**Sub: Renewal and Amendment of the Type B Water Licence No .3BM-IGL 1520 to Type A Water Licence 3AM-IGL-- of the Municipality of Igloolik.**

## Technical Memorandum

<b>Date:</b>	November 19, 2020	<b>From:</b>	Ken Johnson, M.A.Sc., P.Eng.
<b>To:</b>	Bhabesh Roy, M.A.Sc., P.Eng.	<b>Project No.:</b>	OTT-00019838-B0
<b>Prepared By:</b>	Renata Klassen, M.Sc., P.Eng.	<b>Reviewed By:</b>	Ken Johnson, M.A.Sc., P.Eng.
<b>Project Name:</b>	Municipality of Igloolik – Water Licence Application Support		
<b>Subject:</b>	Responses to CIRNAC Follow-up Recommendations R-05, R-06, R-09 and R-12 CIRNAC. (2020, October 29). Final Written Submission. Municipality of Igloolik Application for Type A Water Licence 3AM-IGL----.

Figure 2: CGS Maintenance Garage Location and Photo (Google, retrieved November 18, 2020).

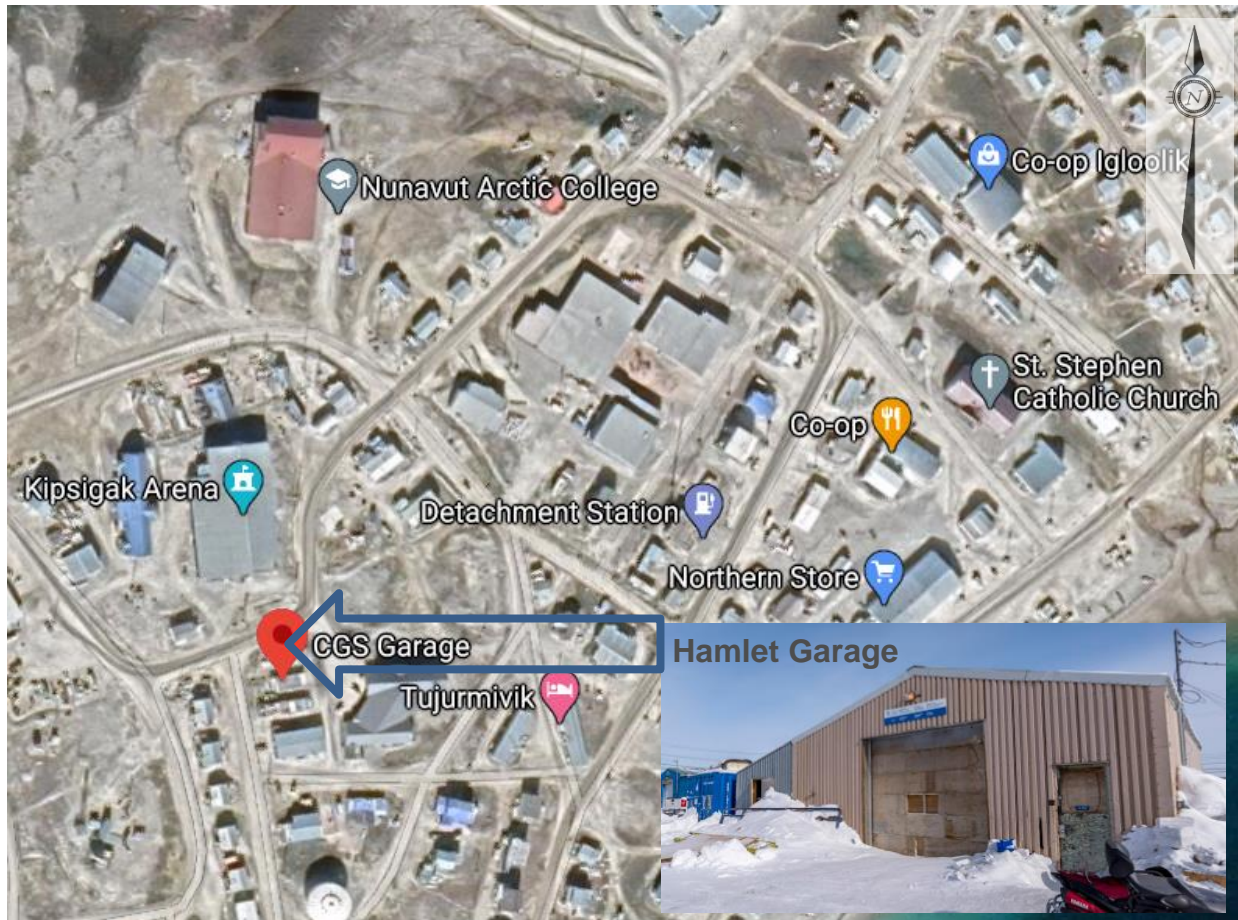
**Recommendation R-05 (1), (2) and (3):** "CIRNAC recommends that GN-CGS include a Municipality map in the O&M Manual which clearly indicates the pathway operators are to take to access the monitoring stations at the filter strip wetland; the locations of safety equipment and spill kits on site, the snow accumulation and dumping areas."

**Response R-05 (2):** Equipment for spills, including spill kits is in the Hamlet garage, as reported by the Municipality. The Hamlet garage location and its photo are included in Figure 2 as observed on Google. The Municipality explains that the present equipment for spills is what the Municipality needs currently.
